GXV3350 Firmware Release Notes

FIRMWARE VERSION 1.0.3.27

GXV3350

ACCOUNT SETTINGS IMPROVEMENT

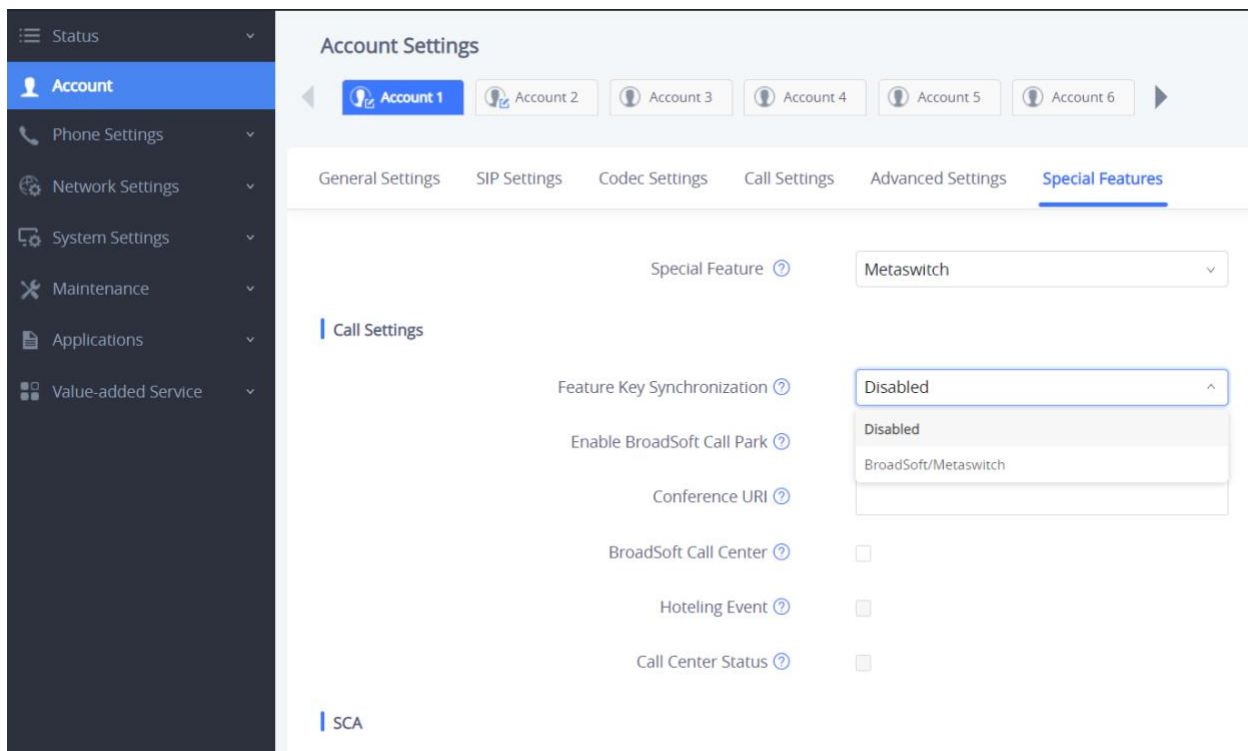
Special Feature tab can be now found under Account settings for each account, where Special Feature, Call Settings and SCA can be found. Feature Key Synchronization setting option to "Broadsoft/Metaswitch". Please find the new layout below.

WEB AUDIO CONTROL

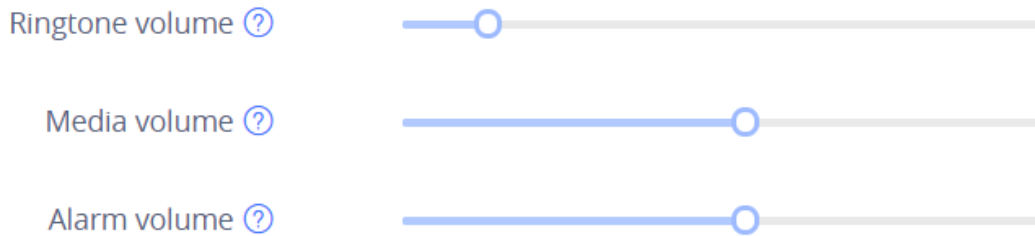
This allows users to adjust different volumes from web UI. This is in web UI -> System Settings -> Preferences -> Audio Control.

CALLEE ID DISPLAY

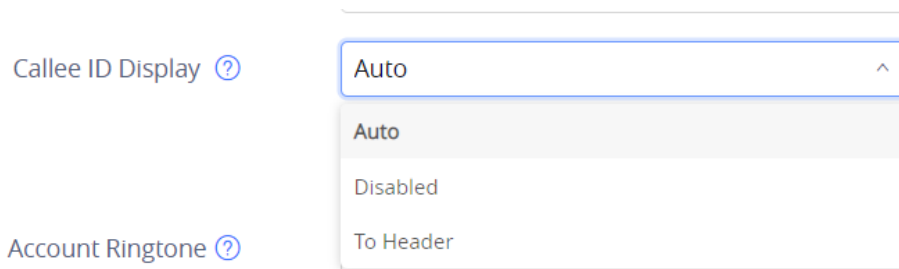
This allows users to configure the source of callee ID. If set to "Auto", if Privacy header is carried in 180 Ringing and the value is "id", "Anonymous" will be displayed on the phone; otherwise, the phone will update the callee ID in the order of P-Asserted-Identity Header, Remote-Party-ID Header and To Header. If set to "Disabled", the callee ID will be displayed as "Unavailable". If set to "To Header", the callee ID will not be updated and displayed as To Header. It is in web UI -> Account -> Call Settings.
